NOTICE OF DECISION

CLASS 3 SITE PLAN REVIEW / CLASS 2 DRIVEWAY APPROACH PERMIT
CASE NO.: SPR-DAP22-48

SUMMARY: Development of a new 850 square foot shop with associated site improvements.

IN THE MATTER OF APPROVAL OF)	FINDINGS & ORDER
CLASS 3 SITE PLAN REVIEW, AND)	
CLASS 2 DRIVEWAY APPROACH PERMIT)	
CASE NO. SPR-DAP22-48)	
2035 WAYSIDE TERRACE NE - 97301)	FEBRUARY 1, 2023

ARCHITECTURAL SITE PLAN

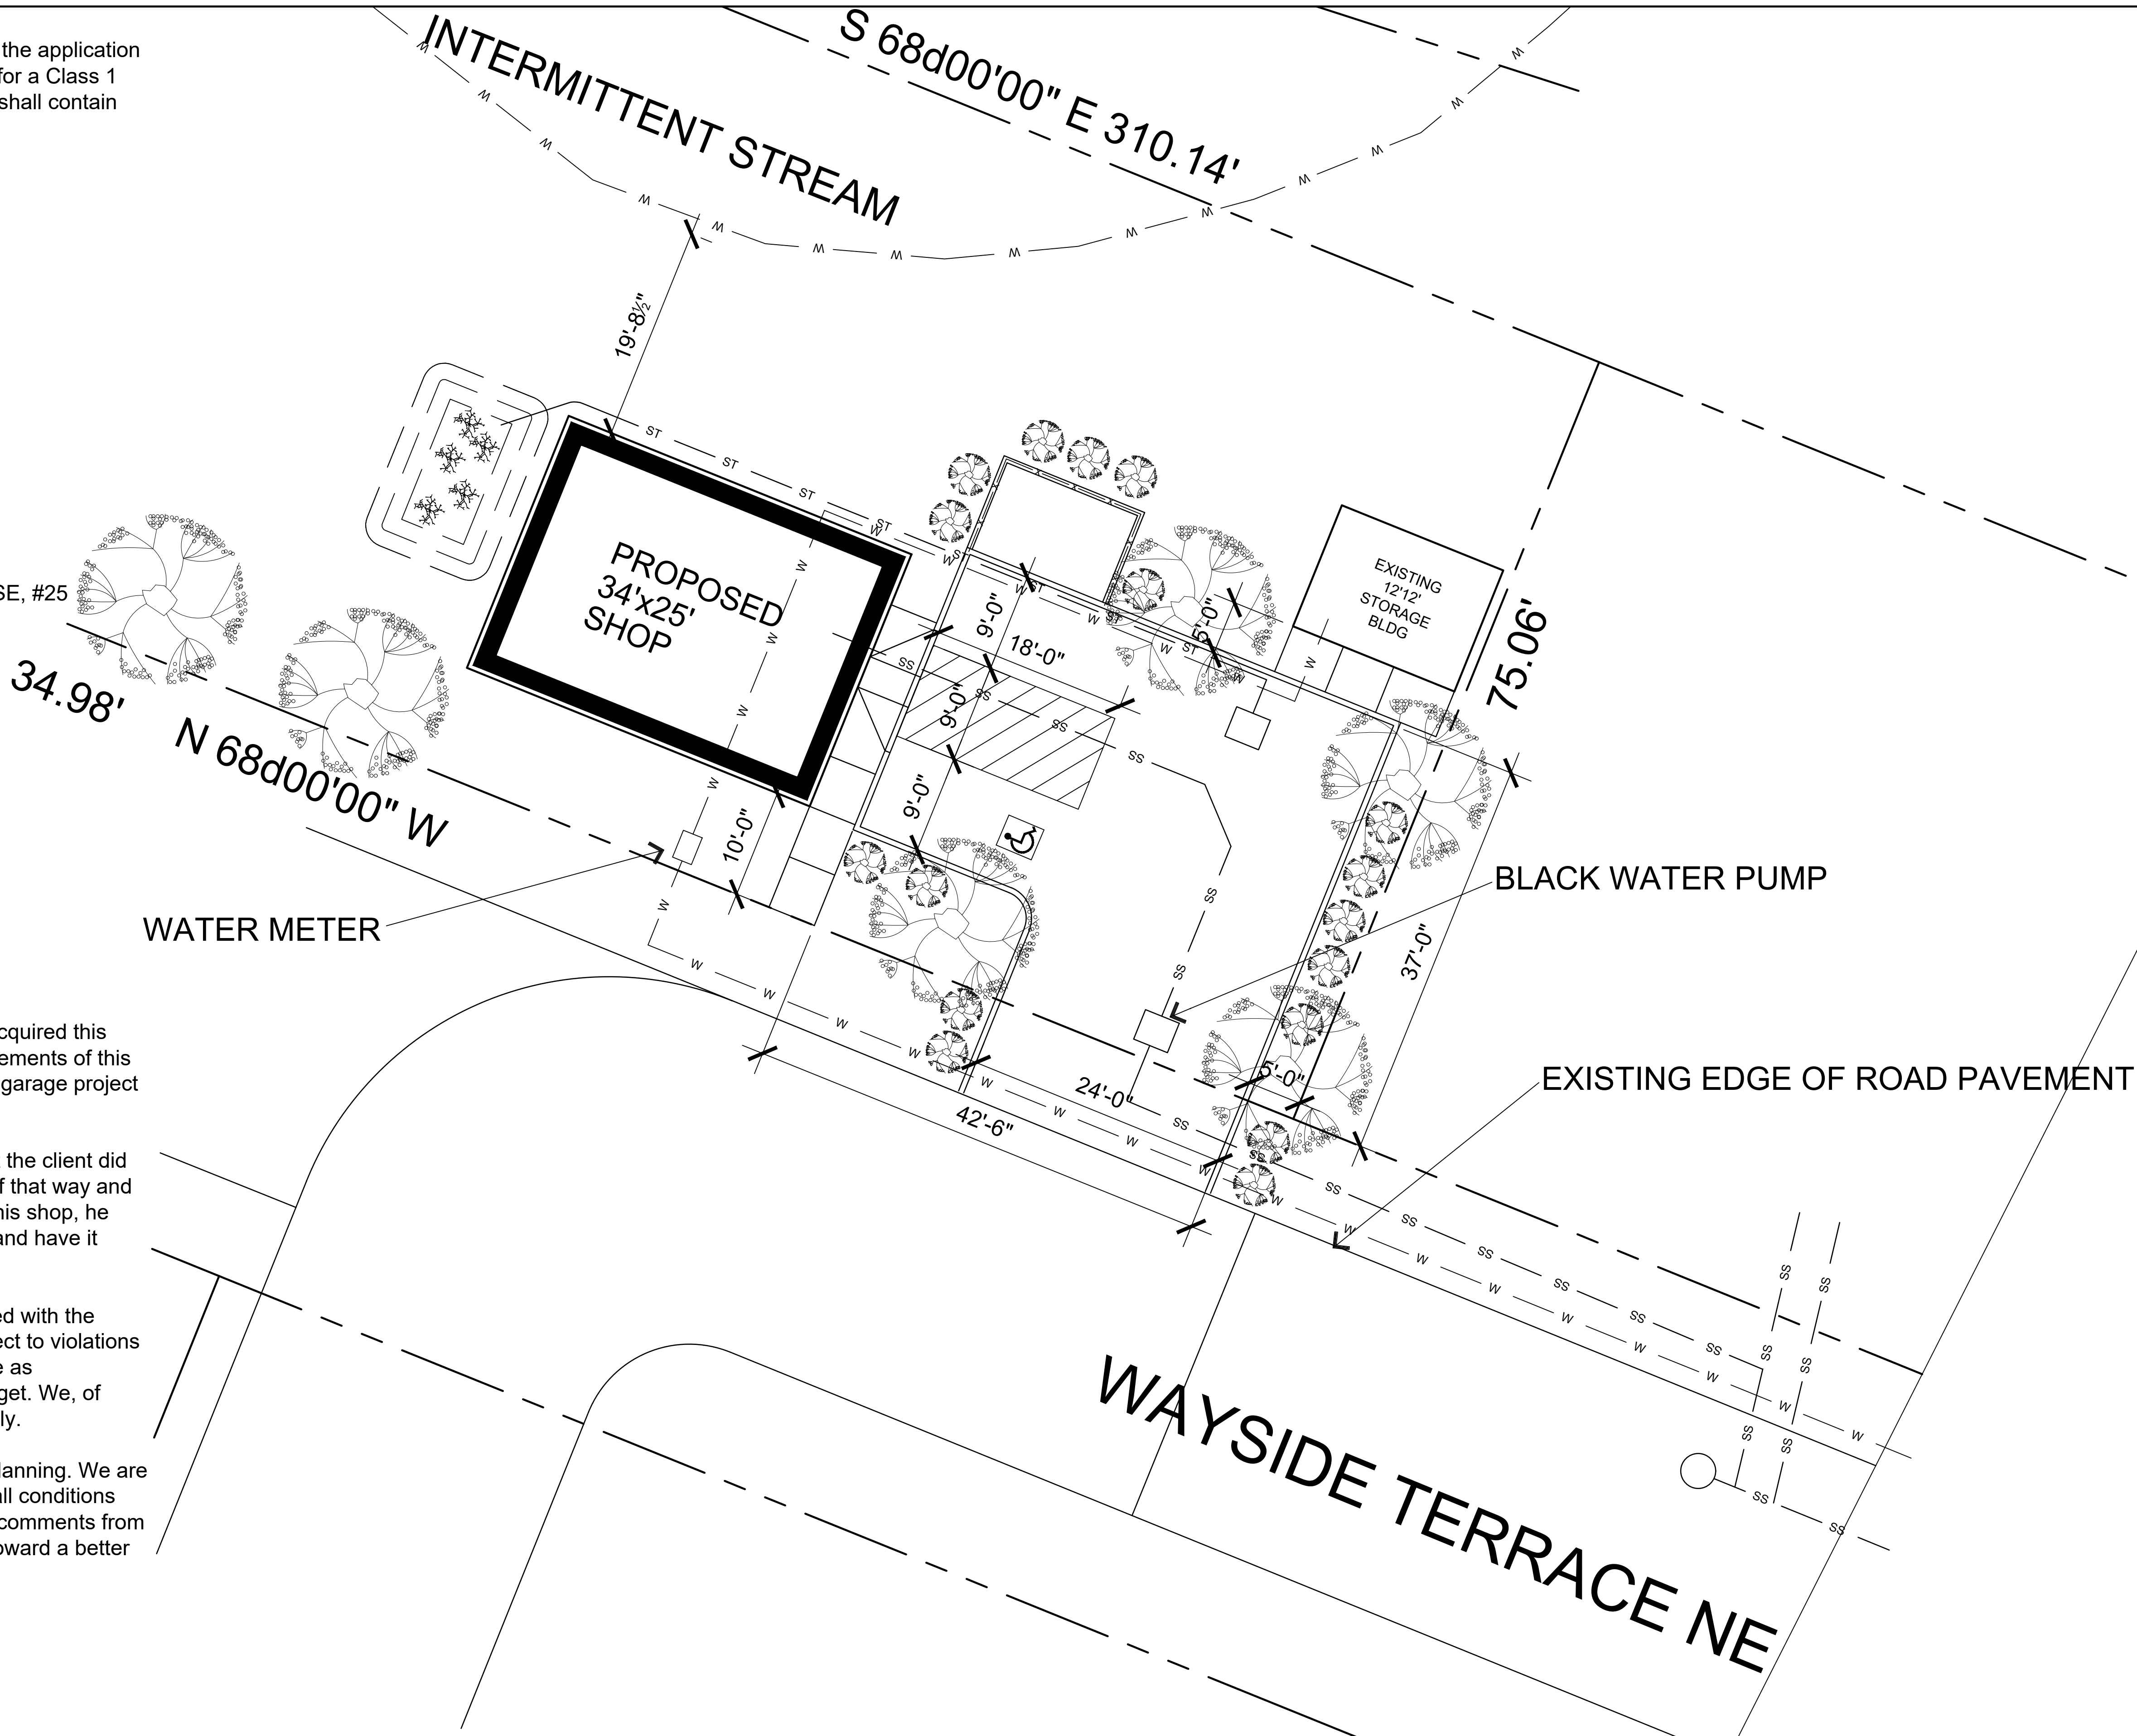
Finding: There is an existing storage shed on site that does not appear to meet the ten-foot setback. In addition, the applicant submitted plans that indicated a ten-foot landscaped setback along the west property line for one sheet, but other plans still show a five-foot setback. As such, the following condition applies:

Finding: The proposed pedestrian connection is at least five feet in width in all locations. The type of material proposed for the pedestrian connections is not listed in the application materials. At the time of building permit, the applicant shall demonstrate that all applicable standards of this section are met. To ensure that the proposed pedestrian walkway meets the design and material standards, the following condition applies:

Finding: The proposed off-street parking area is developed consistent with the additional development standards for grade, surfacing, and drainage. The parking area striping, marking, signage, and lighting shall comply with SRC 806.035, and will be evaluated at the time of building permit review. Off-street parking and vehicle use areas shall include bumper guards or wheel barriers so that no portion of a vehicle will overhang or project into required setbacks and landscaped areas or pedestrian walkways. To ensure compliance, the following condition applies:

Finding: The applicant did not submit a total square footage of landscape to be provided on site. However, the majority of the site will preserve existing landscape along Claggett Creek, or remain undeveloped. The applicant's plans indicate landscape in all required setbacks and appears to meet the minimum requirements for landscaping. To ensure that the required number of plant units will be provided at the time of building permit review, the following condition applies:

Condition 1: At the time of building permit review, the applicant shall revise all plans to indicate a ten-foot setback for the vehicle use area and existing storage shed abutting the east property line, including Type C landscaping with a six-foot-high sight-obscuring fence.

Condition 2: At the time of building permit review, the applicant shall demonstrate that all required pedestrian connections conform with the design and material requirements of SRC Chapter 800, specifically SRC 800.065(b)(1) and 800.065(c).

Condition 3: At the time of building permit review, the applicant shall provide bumper guards or wheel barriers for each parking space to prevent parked vehicles from encroaching into the pedestrian walkway.

Condition 4: At the time of building permit review, the applicant shall provide a full landscape plan demonstrating how the development site meets Type A or Type C landscaping where applicable, including all new and existing landscaped areas, by providing a minimum of one plant unit per 20 square feet, with 40 percent of the plant units being trees.
